AUSTIN WATER UTILITY
Utility Development Services Division
625 East 10th Street
Austin, Texas 78701
(512) 972-0207 fax: (512) 972-0251

Re: 2700 Edgewater Drive

RE: Changes requested for the OSSF Located at 2700 Edgewater Drive

RE: Chelstrom House
2700 Edgewater
Austin, Texas

Project: CHELSTROM HOUSE	Engineer:
Job No: 20082710	Date: 5/31/11
	Page: SK-1

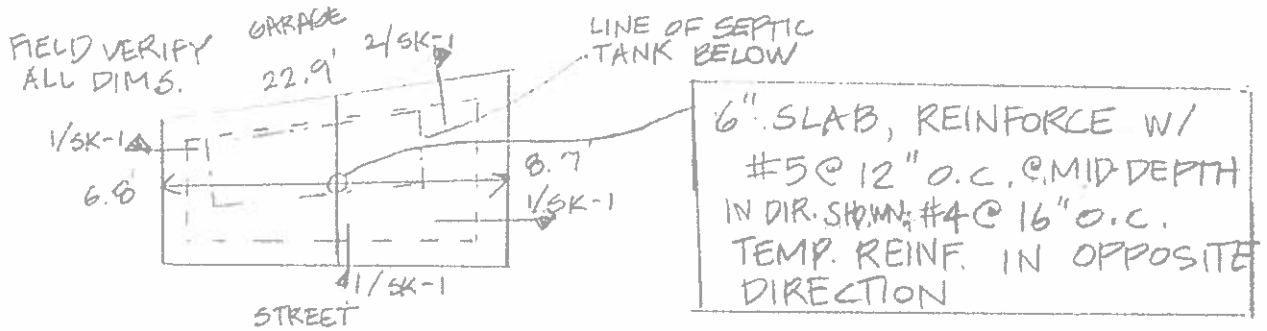
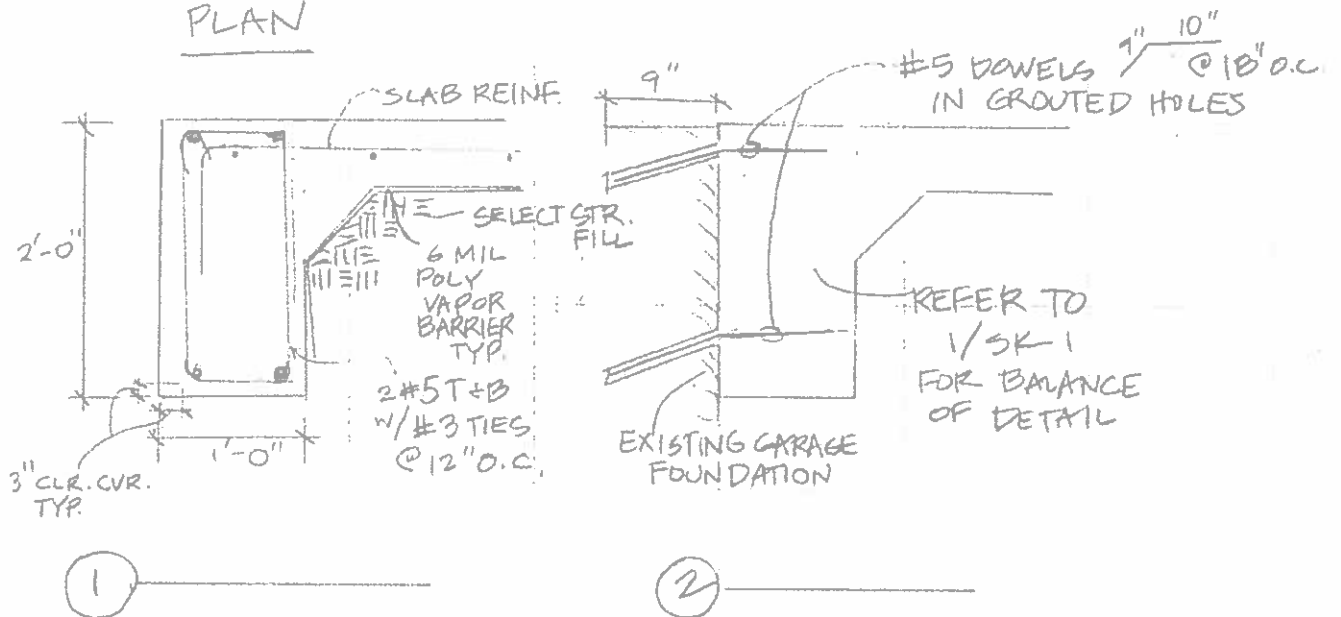
A 6" concrete slab with #5 reinforcing bars at 12" O.C. spanning across the septic tank in the direction shown on SK-1 shall suffice. Provide #4 reinforcing bars in the opposite direction at 16" o.c. to satisfy temperature reinforcing requirements. A grade beam 24" deep x 12" wide shall be continuous at the entire perimeter of the slab with (2) #5 bars top and bottom continuous and #3 concrete ties at 12" o.c., as shown in detail 1/SK-1. At the existing garage foundation, provide dowels top and bottom as shown in detail 2/SK-1. See sketch SK-1 for additional information. All plan dimensions shall be field verified.

Project: CHELSTROM HOUSE	Engineer:
Job No: 20082710	Date: 5/31/11
	Page: SK-2

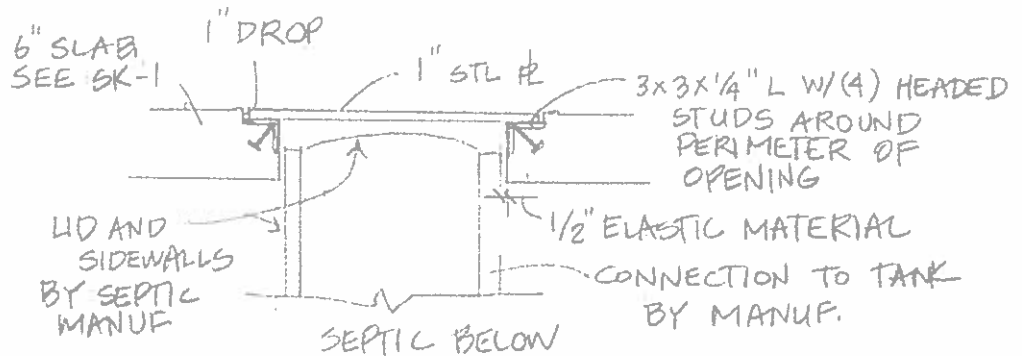
At opening for access to the septic tank in the driveway, use detail 1/SK-2. Coordinate location and dimensions of all openings with manufacturer.

COORDINATE ALL SEPTIC SYSTEM DIMENSIONS
AND LOCATION OF OPENINGS W/ MANUFACTURER
